Your Ref  
WA/90/18/HH  
Our Ref  
PLAN-025736  
Date  
03/12/2018

**Proposal: Retrospective application for rear single storey extension.**  
**Site: Chillerton Down, Yapton Lane, Walberton BN18 0AN.**  
**WA/90/18/HH**

Due to surface water inundation issues in the Lidsey Catchment "The applicant is advised to adopt, where appropriate, the measures in the table "Practical measures to reduce the potential impacts of development".

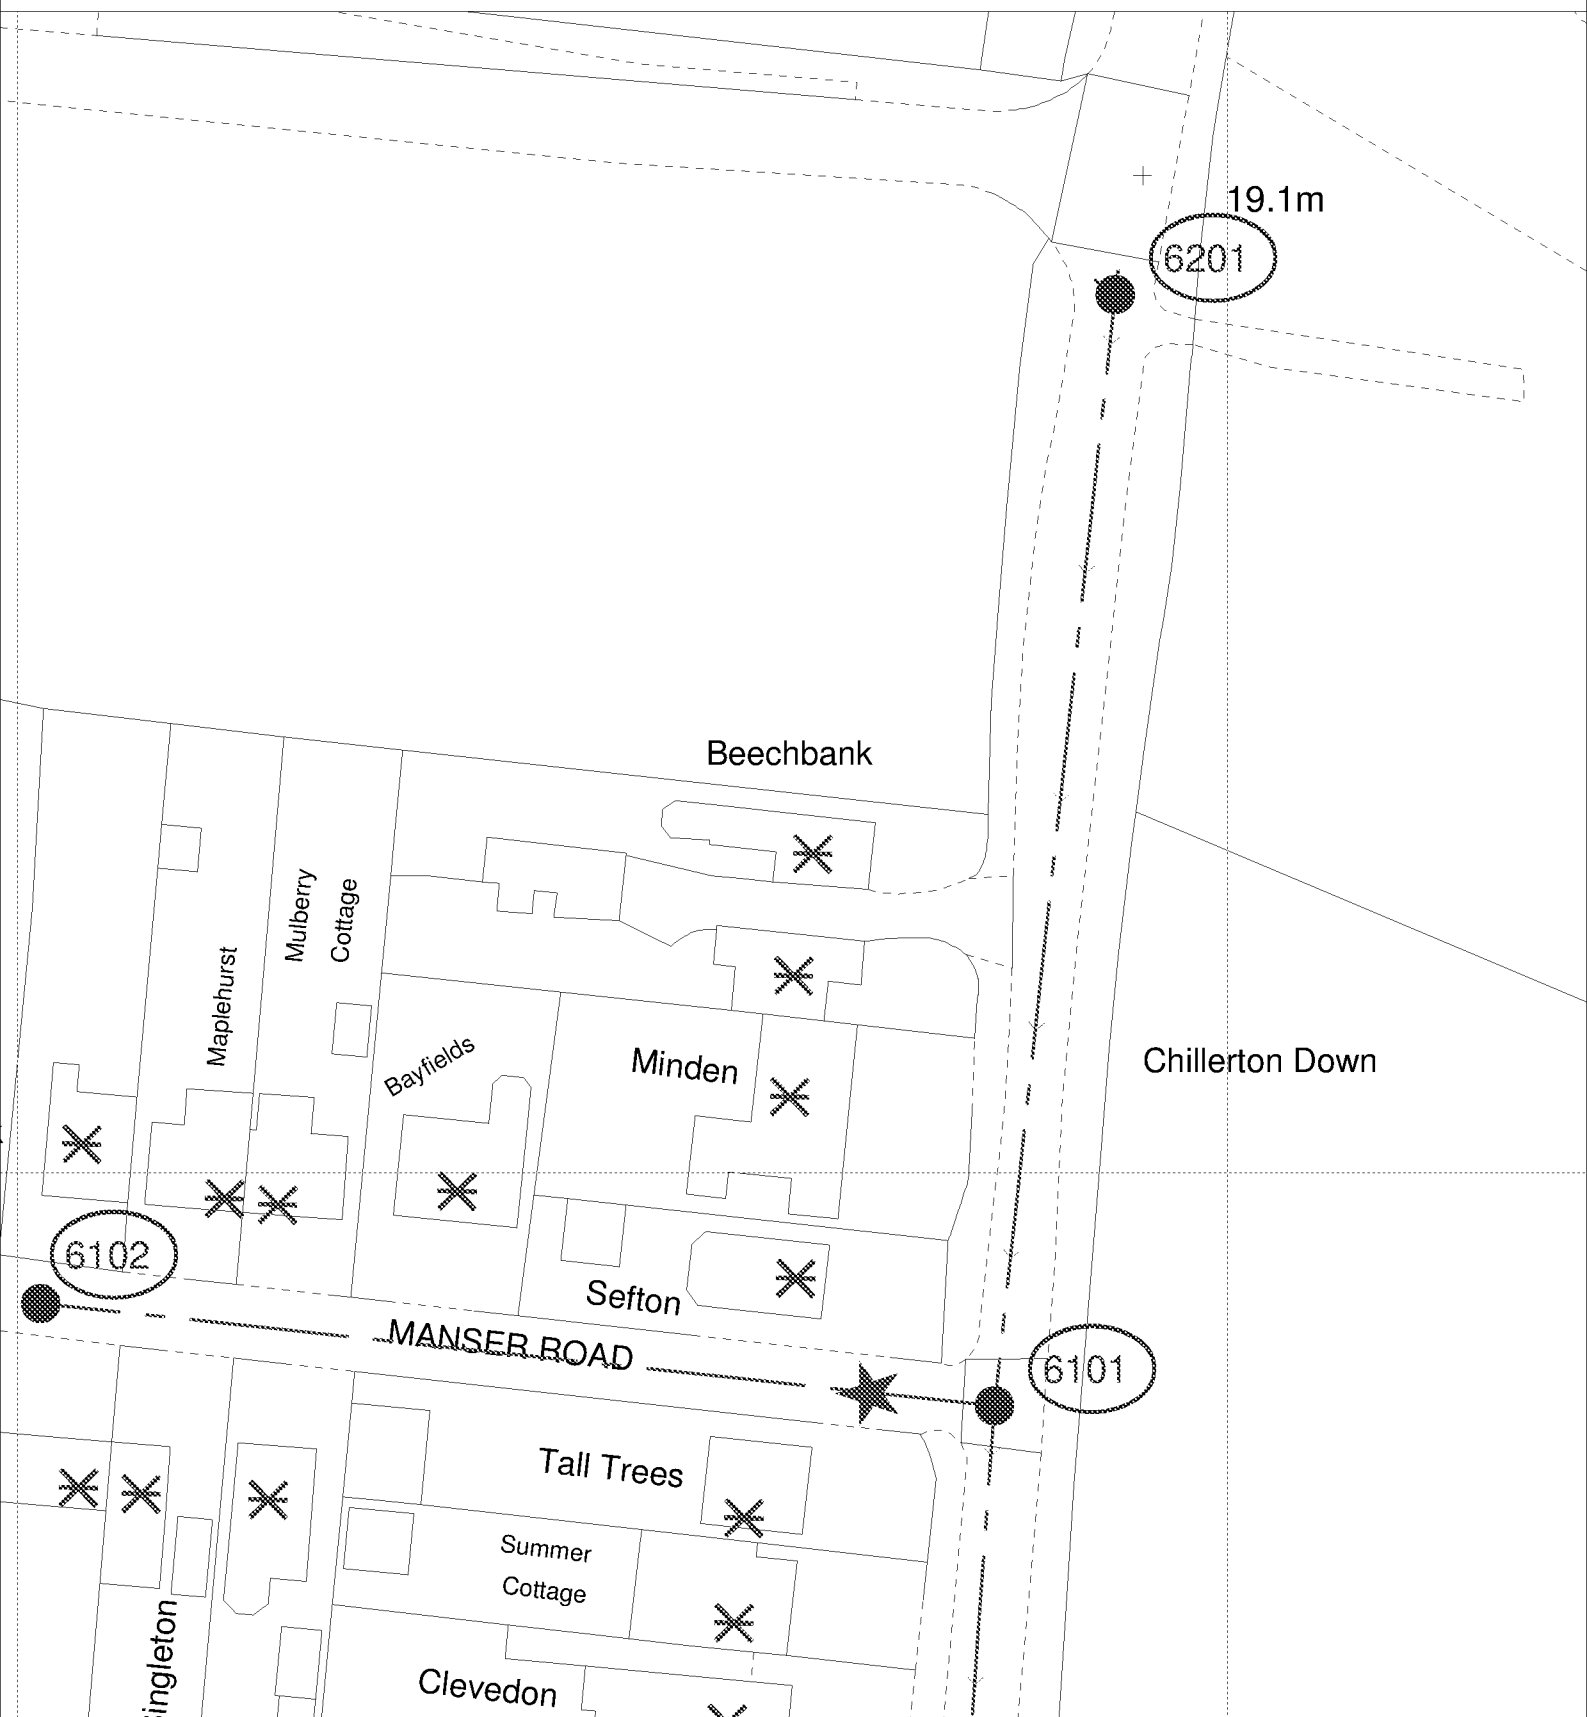
Developer should look to protect the public sewerage system from inundation and infiltration, which contribute to flooding in unfavourable conditions.
